TAC MEETING #1

FEBRUARY 4. 2022

TECHNICAL ADVISORY COMMITTEE

City of Saint Paul

200' ROW, Single Median

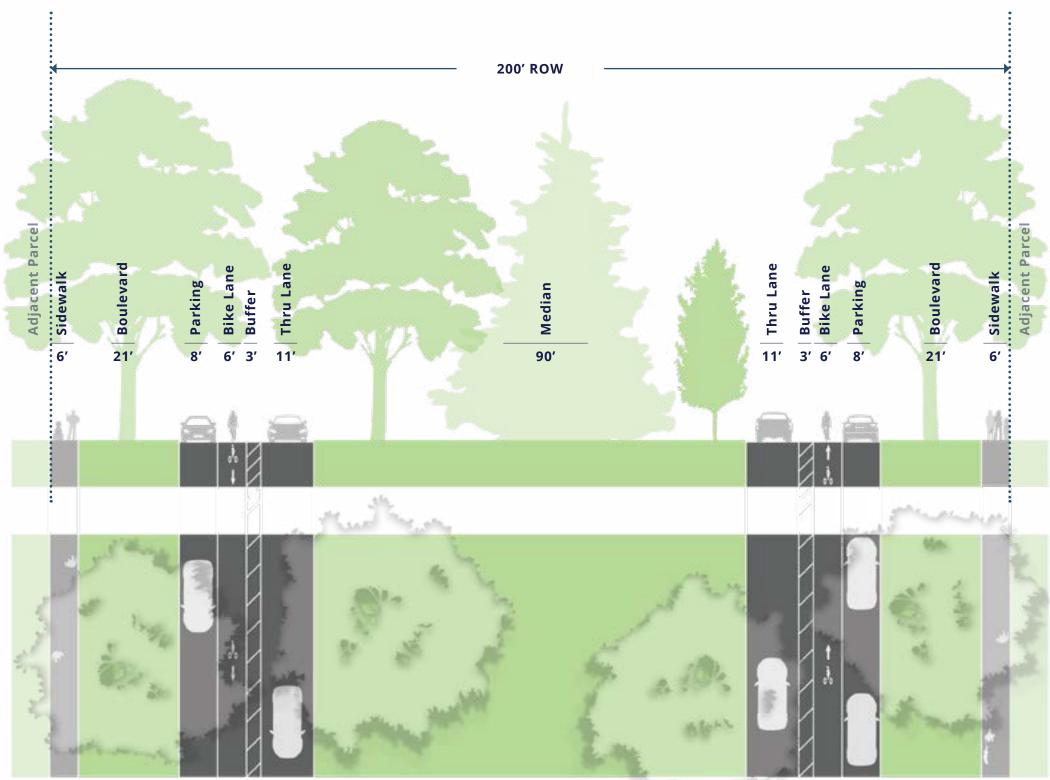
Makes the most sense to me for the trail to be in the Center median, especially if some of the existing roadway crossings through the median could be eliminated or narrowed. I like this option because it is consistent with how people use Summit Avenue today, and leaves the existing sidewalks in place. Primary question to explore is whether this would allow narrowing the roadway segments to remove the bike lanes and/or buffers to offset the additional pavement.

Remove bike and buffer from roadway. Add bike facility behind the curb on the sidewalk side. One way on each side.

Advantage is that you are basically swapping space by narrowing the roadways and putting bike and buffer behind curb, so no major impact to trees or how the corridor functions. Disadvantage is that some bikers may not adhere to the indicated one way direction

one way bikeway against the curb on either side (9' including some vertical separation/buffer | parking | 11' travel).

- Adv: doesn't mess with the curb lines; doesn't impact trees or green space; doesn't add new impervious surface; one way bikeway makes traffic intuitive from a bike perspective and a driver perspective no median crossings of cross streets for people biking on median; no real change to the median at all!
- Disadv: unique design in Saint Paul (parking protected bikeway; cars parked in "middle" of street), so unique maintenance, but wouldn't add NEW maintenance (relative to a bikeway in the median)

two way bikeway on median (gotta be wide enough to acknowledge the fact people walking and biking will both want to use it)

- Adv: A new bituminous surface on the median will likely last longer/ require less maintenance; this would likely be the most comfortable facility...outside of street crossings (which is a big source of discomfort!!); major advantage is that we could decrease the width of the street if no bike lane if/when we reconstruct these segments (could be AT LEAST 9' narrower of a crossing without the bike lane/buffer). This would be in line with modal hierarchy and policy from the Comp Plan -Disadv: I think street crossings of a median running bikeway will be the biggest challenge: visibility, legibility (which mode yields to which at conflict points); tree removal will be contentious; you'll get walkers and bikers both wanting to use the bikeway, whether you sign it as bike only or not

1. As is with reduced parking to improve sightlines and reduce likliehood of cyclists being doored. Pros: keeps cyclists moving with flow of traffic, preserves natural
space. Cons: Some folks just won't be comfortable riding on the road. This is okay, but I think I'd like the design team to try to do something different to see what is
possible. Especially if the above curb stretch could continue to Ayd Mill.

2. Above curb bike trail on both sides of median. Pros: keep moving with direction of traffic. accessible to users that aren't comfortable on road. Cons: "cliff" feeling if the trail is so close to the road without a buffer. Not sure how cyclists would respond if this ends up being crowded. Challenge: Make it easy to get on and off at side street intersections - right turns. This is what I would love to see the design team explore.

I do not like the idea of a Bike trail down center of median. It would introduce too much pavement and conflict with pedestrians who naturally walk down the center of the median. Since there are sidewalks on both sides of the street, I think the median center pedestrian path should remain unpaved. Perhaps with crushed limestone?

I envision a two way raised trail with a buffer, on either side of the road, whichever side can be made continuous (ie. not jogging of the trail back and forth through the corridor) with the other roadway sections. This has the advantage of using the existing road area and is within the existing curblines and will preserve the historic and park like nature of Summit. This alignment also prevents vehicle traffic from degrading the path and allows for separate snow removal of the path and provides space in the buffer for snow plowed from the road. This has the disadvantage of potentially confusing two-way bike traffic for cars (though Wheelock and Como both have a similar alignment) and removing parking on one side of the road.

One-way raised trails could also be on both sides of the road, against the curb, with parking between the bike trail and the travel lanes. A visual buffer would be provided to separate the trail from the parking strip. This has the advantages of keeping cars from entering the trails and degrading the pavement and may be easier to connect with other road sections. It also keeps bikes moving with the direction of traffic and utilizes the existing road section. Snow removal may be more of an issue, as plowed snow from the parking strips may get on the paths.

If a trail is put within the median it will increase the impervious areas that will need stormwater treatment as well as impacting the park like feel of Summit and likely requiring tree removal or damaging tree roots. It also creates a dangerous situation of bikes crossing in the center of intersections, which may not be expected by drivers. This is the most difficult alignment to connect with the other sections of the road.

Down the center; similar to Victory Memorial Trail; advantage would be a grade separated bike trail and disadvantage would be rerouting trail through intersections.

Through the median, winding open space park-like feel around the trees. Or on one side, replacing sidewalk, as a wider shared-use trail (respecting the urban setting and causing less impact to the center median and its formal lawn-like setting.

I think that separate bike and ped facilities are key. I would envision 2 one-way bike trails to be located adjacent to the travel lanes, either 1) as part a new extended boulevard where the parking lane is currently (and the parking lane be shifted over to next to the travel lane), or as 2) part of a new extended median where the travel lane is currently (and having the travel lane get shifted over to be next to the parking lane. For 1), we would need to make sure that there is enough space between the parking lane and the bike trail to avoid doors swinging into bicyclists. Disadvantages to both of these would be if the existing trees would have to be removed.

I personally think that this cross section is so wide and there would be enough space for both parking and a travel lane even with the pavement being narrowed as the curbs are extended for a bike trail. On-street parking can also help with traffic calming and I don't think that the residents and institutions along Summit would be happy to have their parking removed considering that many of the blocks are long and there are not too many side street connections. If necessary to remove parking, I would advocate that only one side would be removed.

I could see also see the new bike trail being in the middle center median, but it appears that there already are non-maintained unpaved trails that get heavily utilized by runners, and I think that having the trails be near the driving lanes is a better option because it doesn't disrupt that and the existing vegetation/trees. I also think that it would be more pleasant for bicyclists to be closer to the street and sidewalk vs. in the center median. I personally like biking with close views of the nice/historic houses along Summit.

First choice would be to widen the ROW on each side of the central blvd by shrinking the width of the central blvd a bit, but that isn't okay if it cuts a lot of tree roots for large trees and make them die. The added width would be for more bike lane space on each side. Second choice would be to make one side of the blvd for cars (2-way) and the other side of the blvd for bicycles. In either case, on street parking on both sides of the blvd is important because people can't reasonably be expected to cross a blvd and 2 lanes of traffic to get to their car.

I can envision a trail going right in the median. People love running and hiking between the trees in the median.

I prefer to see separate bike and pedestrian facilities to avoid potential collisions and prevent becoming a victim of bike trail accidents. In terms of the bike facility itself, I'd prefer to see 2 separate facilities for the bike trail (1 in each direction). I bike on the Dakota Rail Regional Trail with my family and it's a single shared-use facility. It's impossible to push a stroller or enjoy the trail while hiking. It's a regional trail and it tends to attract hardcore bikers who see pedestrians as more of a nuisance. The trail feels highly dangerous especially for a family with young kids who may be pushing a stroller or who may happen to have a child that's just starting to bike. We're constantly worrying about having a head-on collision with opposing bike traffic.

The disadvantage of having multiple facilities is the upkeep it requires and the difficult transitions one has to navigate while crossing one segment of the trail to the next.

Parking access to a regional trail is important if the goal is to make the trail more accessible. Otherwise, it risks becoming a neighborhood trail.

Right down the middle.

Keeps people off the roadway

Near road on the median for cyclists; sidewalk for pedestrians. Separates peds/cyclists/vehicles and still gives use to the green space in the median. A big disadvantage could be any intersection. Anyone taking a left or trying to cross the street has around 4 or 5 intersections to cross. Mitigated with good signage? Could there be a way to connect Summit to Ayd Mill? Maybe a better way to get to Grand via Griggs? Could see people trying to get access to that corridor.

First choice within the existing road bed to avoid impacts to, or the removal of the existing parkway trees as well as the loss of available soil volumes. The large boulevards and median provide beneficial growing conditions to establish large canopy trees. These conditions are not found widely in the city and provide a unique opportunity to a diverse mix of large trees not suitable for narrower boulevards.

Second choice would be to locate the trail in the median. The pathway would ideally be routed to avoid impacts to large, existing trees - especially any designated landmark trees or other significant trees.

Narrowing the north and south boulevards is not preferred as it could cause damage to the existing trees and reduce available soil volumes for the establishment of large trees. Narrowing the median raises similar concerns.

Yes. A trail can be added where the parking exists today. Locating the trail above the curb and adjacent to the boulevard seems safer for the bikers as compared to being between parked and moving cars.

200' ROW, Double Median

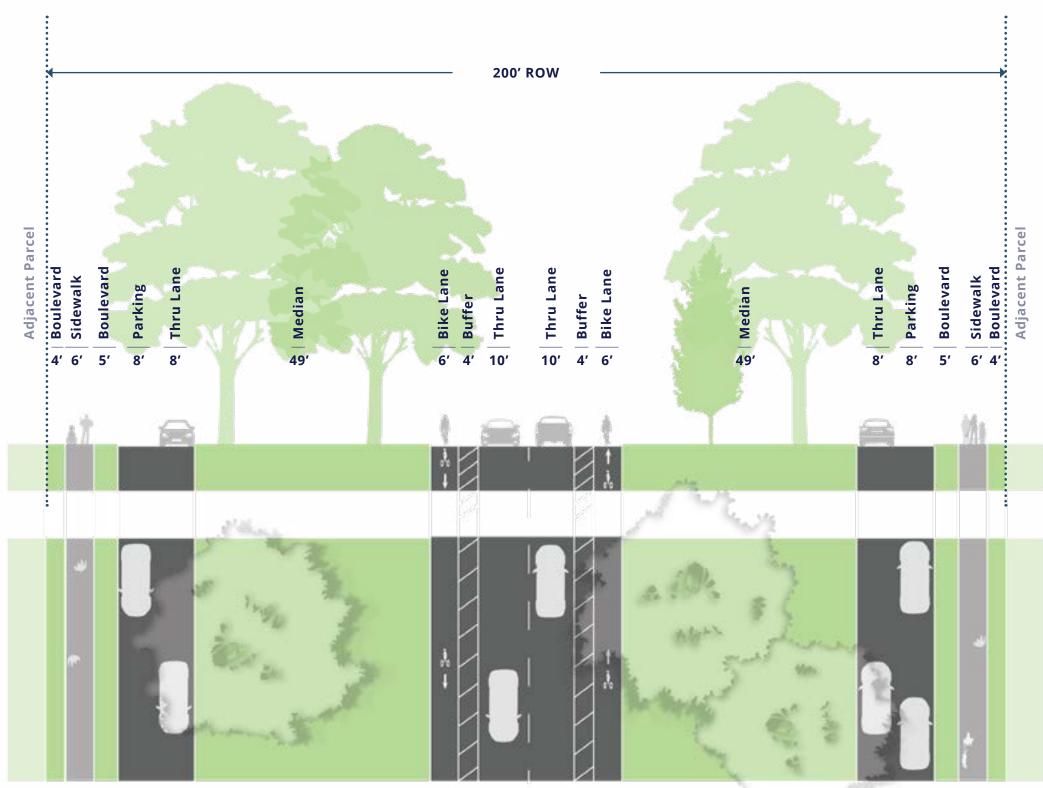
TAC Member Comments2
DOUBLE MEDIAN SECTION
Would recommend placing the trail in one of the two medians. The existing bike lanes and/or buffers could be removed from the central roadway to allow it to be narrowed to offset the addition of new pavement for the trail.
same as previous section
Remove or limit car access on "frontage" roads, turn these into one way bike ways, move parking to the space now occupied by the bike lanes - Adv: no new pavement; no loss of trees; no new plowing; likely the frontage roads will last longer as bikeways than as they exist now; no loss of parking - Disadv: driveway access (though several have alley access); people parking would have to walk across the medians to access properties on Summit - how do they do that with snow/how do you make it accessible
One way bikeways on each median - similar adv and disadv to what I list previously
Two way bikeway on one median - similar adv and disadv to what I list previously

I think a trail on each side, going with traffic direction, would be great. So, just pushing into the median a bit and using the space from the on road buffer to build a curb and keep the vehicle lane narrow. Prevent the "cliff" feeling of being on a trail without separation from the road. I think you have a lot to work with. The status quo is fine for most of this stretch since the bike lane does not pass parked cars, but, since it's on road some folks will not use it.

I participated in the break out session for this cross section. Several excellent options are available, including using either one of the frontage roads for a two-way, completely separated cycle track. This could easily be connected with a two-way trail from the single median section. It creates easier maintenance and snow removal while utilizing existing road infrastructure and preserving Summit's trees and park-like feel. Any parking lost on the frontage road could be replaced on the main road. Ensuring that houses that use the frontage road have alley access will be critical. This option may also allow for capping of the frontage roads, except for the bike trail, removing pavement, potentially creating additional greenspace and allowing better access to greenspace in the medians and better traffic control at intersections.

A two-way cycle track on either side of the main road and shifting the travel lanes is another option. This has the advantage of using the existing road area and is within the existing curblines and will preserve the historic and park like nature of Summit. This alignment also prevents vehicle traffic from degrading the path and allows for separate snow removal of the path and provides space in the buffer for snow plowed from the road. This has the disadvantage of potentially confusing two-way bike traffic for cars (though Wheelock and Como both have a similar alignment) and removing parking on one side of the road.

One-way raised trails could also be on both sides of the road, against the curb, with parking between the bike trail and the travel lanes. A visual buffer would be provided to separate the trail from the parking strip. This has the advantages of keeping cars from entering the trails and degrading the pavement and may be easier to connect with other road sections. It also keeps bikes moving with the direction of traffic and utilizes the existing road section. Snow removal may be more of an issue, as plowed snow from the parking strips may get on the paths.

A trail within the medians should not be considered, as it will create dangerous crossings at intersections, will create additional pavement that will need stormwater treatment and will remove trees and other vegetation.

Consolidate both bike directions and walkway on north of Summit; make the other into a closed off frontage rd (up to Snelling) for home driveway access.

Remove bike lanes, add parking to the center - devoting the central corridor to vehicles. The parking provides access to users (non-residents) and to residents (especially those who are about to 'lose' their frontage). On one of the frontage roads, remove vehicles entirely OR restrict entry to single-block resident access only (bollards or similar) such that the frontage can be reconfigured for shared multi-use regional trail (predominantly bike use). This approach would seem to transition best to a shared-use trail on one side when the road section converts to one road with wide center medians. Some bicyclist types will oppose loss of onroad bike lanes. However a balance must be struck - IMHO to provide separate facility for every mode may be possible without losing character of the district or functionality of the road -but taking that the extra step to provide separate bike facility for every bicyclist TYPE is unsustainable and not warranted. All facilities on all roads does not make complete streets.

I would advocate for trails separate from the pedestrian space and to be one-way because of the wide cross section. I think that a separate one-way bike trails could go close to where the bike lanes are now, but above the curb either within an extended median or shifted to be within the existing median. This would maintain the current bike/ped separation that it has now and maintain the median for other uses. I could also see one-way bike trails go adjacent to the outer travel/parking lanes within the current median space, but this might result in tree removals, which would be a disadvantage. But, I think that having the bike trails further away from the center travel lanes could provide a quieter/more pleasant bicycling experience.
I think the bike lanes work where they are, but with a more defined barrier between them and the cars.
I envision a pedestrian trail in the median(s), and separate one-way bike facilities on the frontage roads. The question I would ask is will I feel safe biking with my 4

year old on the frontage roads? Probably not, but as long as there is a way to keep bike facilities separate from vehicular traffic, there will be a sense of increased security for bikers. The challenge with this configuration is that it will be difficult for residents, the Ramsey Middle school, etc. to lose parking on the frontage roads.
3 roadways seems a little excessive. turn one of the side roads into a trail.
Plenty of room for a mixed use trail

2) 2 one-way bike paths located on the inside of the medians near the road. Could make a good transition from single median section. Keep sidewalks for pedestrians This can keep parking on Summit, separate road users, and keep most of the medians.
Again a trail within the existing readhed is preferred to avoid the damage or removal of existing parkway trees. Adding a trail to either median would reduce both
Again, a trail within the existing roadbed is preferred to avoid the damage or removal of existing parkway trees. Adding a trail to either median would reduce both the existing and future tree canopy. I'd agree with the idea that the frontage streets (?) present a unique opportunity to explore.
A trail could be added in the existing location of this segment with the addition of it being above the curb.

100' ROW, No Median

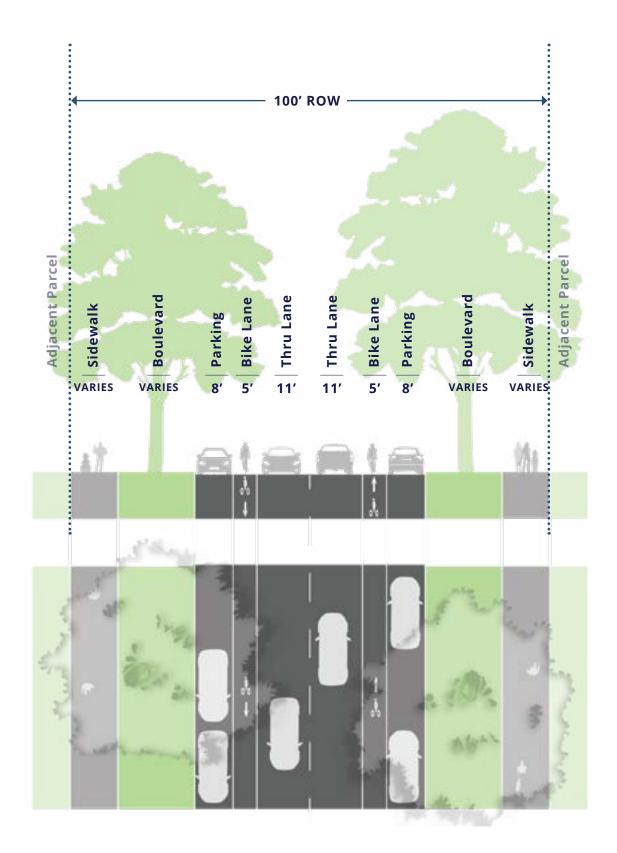
TAC Member Comments3
The Member Commences
NO-MEDIAN SECTION
Trail would best be located within one of the boulevards. Existing sidewalks should be left in place. Should explore removing on-street parking from one side. If parking is removed, and if bike lanes are also removed, a trail and boulevard could largely fit within existing roadway footprint.
Remove bike lanes from roadway. Add bike facility behind curb, either one-way on both sides or a two way on one side. If a two way on one side, one curb line
would move and restriping for the roadway. A two way would lessen maintenance effort.
One way parking protected bikeways against curb + carve out a litttttle bit of the existing boulevard.
- Adv: maintains parking, hopefully minimal impact on trees
- Disadv: doesn't give maximum comfot to people biking; longer crossings remain for people walking.
This segment is tough. obviously.

Where can you of various loca	u envision a trail in the existing cross section? What are the advantages and disadvantag ations?	es
Same as section 2. Ma	aybe reduce parking to one side of street to free up room. I think this is the tightest section and where cyclists are most likely to be doore	1.

I envision a two way raised trail with a buffer, on either side of the road, whichever side can be made continuous (ie. not jogging of the trail back and forth through the corridor) with the other roadway sections. This has the advantage of using the existing road area and is within the existing curblines and will preserve the historic and park like nature of Summit. This alignment also prevents vehicle traffic from degrading the path and allows for separate snow removal of the path and provides space in the buffer for snow plowed from the road. This has the disadvantage of potentially confusing two-way bike traffic for cars (though Wheelock and Como both have a similar alignment) and removing parking on one side of the road.

One-way raised trails could also be on both sides of the road, against the curb, with parking between the bike trail and the travel lanes. A visual buffer would be provided to separate the trail from the parking strip. This has the advantages of keeping cars from entering the trails and degrading the pavement and may be easier to connect with other road sections. It also keeps bikes moving with the direction of traffic and utilizes the existing road section. Snow removal may be more of an issue, as plowed snow from the parking strips may get on the paths.

The sidewalk on one side of the road (whichever better connects with other sections) could also be widened to accommodate bike traffic. This has the advantage of separating bike traffic from the road - lengthening the life of the path and making snow removal easier and preserving parking. It has the disadvantage of creating additional pavement that requires stormwater treatment (extra cost), removal of trees and potential conflicts with pedestrians.

Consolidate both bike directions on south or north of Summit; remove parking on the other side. Disadvantage is no grade separation.

My previous sections #1/#2 seem to tend towards a two-way or shared-use facility on one side. Sticking with that approach (otherwise there seem to be serious challenges with users crossing vehicle thru lanes), sidewalks would remain as-is to accommodates peds, whereas bike/regional multi-use could be supported by eliminating bike lanes, shifting thru lanes to one side (against a parking lane), then removing the other parking lane and using the remaining curb-to-curb for a two-way cycle track. Advantage with respect to historic district is that curb lines remain unaltered (assuming curbs are part of the HWS Cleveland design).

of various locations?
I could see two one-way bike trails going on the other side of the parking lane within an extended boulevard. However, there would need to be enough space to avoid passenger doors swinging into the bike trails. I'm not sure if there would be enough space for this without removing the trees, which would be a huge disadvantage. A consideration to add more space for the trail would be to remove parking on one side of road, but I think that any removal of parking, especially so close to Grand Ave, would get pushback from residents.
Another option could be widening the existing sidewalk to be a wider multi-use trail. Even though I think separation of bike/ped would be ideal, conflicts from doors of parked cars is a bigger concern. Removal of the boulevard trees is also a concern.
Ditch parking on one side of the street and shift both bike lanes to that side of the street. Retain current bike lane widths, plus the parking lane, to have enough width for safe 2-way biking and a barrier between drive lane and bike lanes.

It would be ideal if parking can be removed on the south side (or north) of Summit Avenue and if a pedestrian trail can be added in its replacement. I would still keep the bike facilities as separate one-way facilities. The challenge will be the transition space at intersections and where the ROW narrows at Lexington, etc.
Turn one of the sidewalks into a trail
Turn one of the sidewalks lifto a trail

Just thinking about giving cyclists more space - remove parking on one side of road and permit parking to residents of the street. All this to add buffer zones to the bike lane. I don't think it's possible to put the bike path on the boulevard because of trees. This plan might also not be possible as it would likely have neighborhood pushback. If anything, make these bike lanes more usable.
Within the existing roadbed, eliminating parking on one side of the street if additional space is needed.
Yes. The above the curb trail could be added where the parked cars exists today. Locating the trail adjacent to the boulevard seems safer as compared to sandwiching the bikers between parked and moving cars.
